# 2001 GL1800 Coolant Temperature Gauge Improvement

1 of 2 MTB 9097 (0012)

## GL1800 #1 DECEMBER 2000

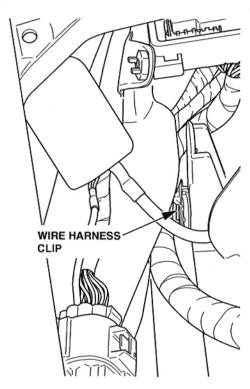
- Remove the left-side fairing pocket. To remove the trim-clips, push in on the center pin (For further details on trim-clip procedures see *The Wrench*, April 1994).
- 2. Remove the WHITE connector holder:
  - Loosen the 2 fixing screws on the left side of the connector holder. Loosen the screws several turns, but do NOT remove them.

Remove the wire harness clip below the WHITE connector holder. Discard the clip

- Pull the connector holder to the right, away from the fixing screws. Then, pull the holder up and back into the fairing pocket area.
- Remove and unplug the BLUE connector from the holder.
- Snap the female sub-harness connector onto the connector holder in place of the original BLUE connector.
- The original BLUE female connector now snaps onto the right side of the connector holder.
